SUBDIVISION COMMITTEE
METROPOLITAN AREA PLANNING COMMISSION

STAFF REPORT

CASE NUMBER: S/D 92-67 - ROCKWOOD CENTER 2ND ADDITION

STAFF REPORT
(Preliminary Plat)

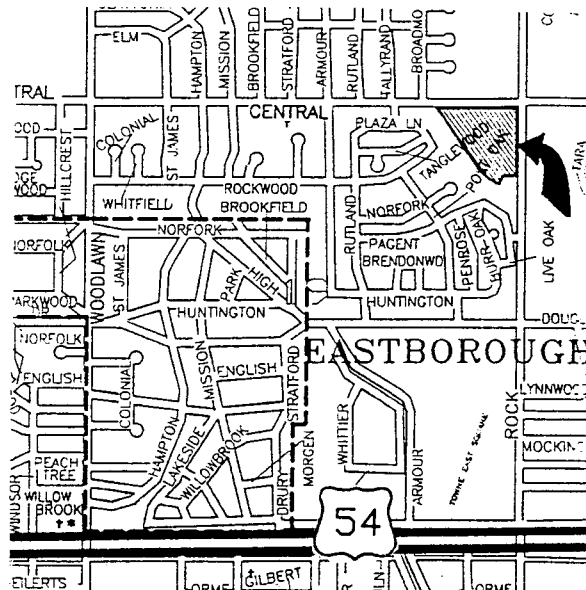
- A. The applicant shall guarantee the extension of sanitary sewer to Lots 2 and 3. Square footage figures shall also be submitted to Engineering so that existing guarantees may be redistributed.

- B. The applicant shall submit a guarantee to extend the decel lane, needed for this site, along Central.
- C. If improvements are guaranteed by petition, a notarized certificate listing the petitions shall be submitted to the Planning Department for recording.

- D. The applicant is advised that the comments and conditions concerning the pipeline(s) on this site, noted during review of the Rockwood Center Addition plat, are still applicable to this replat.

- E. Since Lot 3 has no direct access to an abutting public street (Central), the applicant was either to provide an ingress-egress easement to this site across Lot 4 or create a cross-lot access agreement which assures unencumbered access for Lot 3. In either case, such a document needs to be reviewed and approved by Planning prior to such a document being recorded by the applicant. Since an easement is being created, it shall be shown on the final plat tracing with the appropriate recording information. A recorded copy of such document shall also be submitted for the plat file.

- F. Since Lots 1 & 2 are sharing an access opening, to Central, an agreement shall also be provided for this situation. Again, recording information needs to be shown in the final plat tracing, and a copy of the recorded document submitted for the plat file.

- G. The applicant is advised that this site is still subject to various screening and landscaping requirements as specified in DP-41, Amendment #1.
- H. The applicant shall submit an avigational easement covering all of subject plat and a restrictive covenant assuring that adequate

construction methods will be used to minimize the effects of noise pollution in the habitable structures constructed on subject property.

- I. On the final plat tracing, the name of the partnership shall be printed above the signature of W. W. Taylor.
- J. As indicated by the platting binder, property taxes on this site are unpaid. Before release of the plat for recording, the applicant shall provide proof that all applicable property taxes have been paid.

- M. Perimeter closure computations shall be submitted with the final plat tracing. Section 5-101(c).
- N. Recording of the plat within 30 days after approval by the City Council.

- O. The representative from City Engineering should be prepared to comment on the status of the applicant's drainage plan.

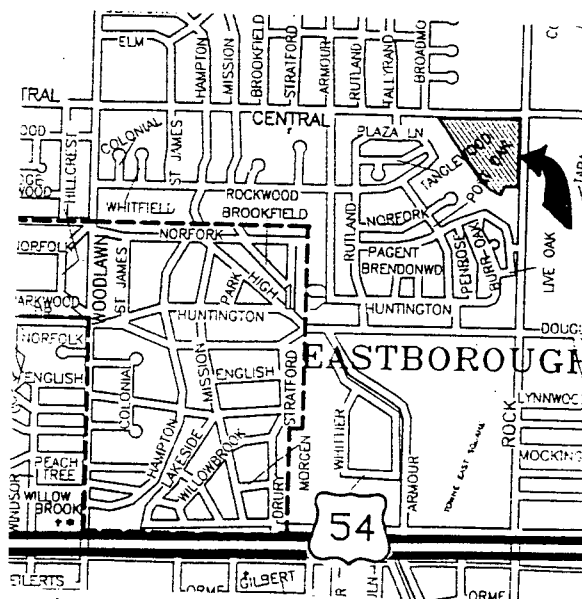
- A. City Engineering needs to indicate any requirements concerning existing guarantees for this site and/or if any additional guarantees are required. Specifically, are any projects needing to be abandoned or are agreements needed to redistribute existing specials. Also, are any new guarantees needed for the extension of sanitary sewer such as to Lot 3 or for drainage improvements, including cross-lot drainage agreements.

- C. The applicant is advised that the comments and conditions concerning the pipeline(s) on this site, noted during review of the Rockwood Center Addition plat, are still applicable to this replat.

- D. Since Lot 3 has no direct access to an abutting public street (Central), the applicant shall either provide an ingress-egress easement to this site across Lot 4 or create a cross-lot access agreement which assures unencumbered access for Lot 3. In either case, such documents need to be reviewed and approved by Planning prior to such documents being recorded by the applicant. If an easement is created, it shall be shown on the final plat tracing with the appropriate recording information. Recorded copies of such documents shall also be submitted for the plat file.

- E. Since Lots 1 & 2 are sharing an access opening, to Central, an agreement shall also be provided for this situation. Again, recording information needs to be shown in the final plat tracing, and a copy of the recorded document submitted for the plat file.

- F. On the final plat tracing, it shall be indicated both in the plat's text and by a note on the face of the plat that building setback requirements are per the Rockwood Center Commercial C.U.P., DP-41 (Amendment #1).

- G. The applicant is advised that this site is still subject to various screening and landscaping requirements as specified in DP-41, Amendment #1.
- H. The applicant shall submit an avigational easement covering all of subject plat and a restrictive covenant assuring that adequate construction methods will be used to minimize the effects of noise pollution in the habitable structures constructed on subject property.

- J. Requirements for a final plat (see pages 24-29, Part 4, Article 5 of the MAPC Subdivision Regulations).
- K. Prior to or at the time of submitting the final plat, the applicant shall submit a drainage plan to City Engineering for review and approval.

- M. The representatives from the utility companies should be prepared to comment on the need for utility easements to be platted on this property.
- N. The representative from City Engineering should be prepared to comment on the status of the applicant's drainage concept.
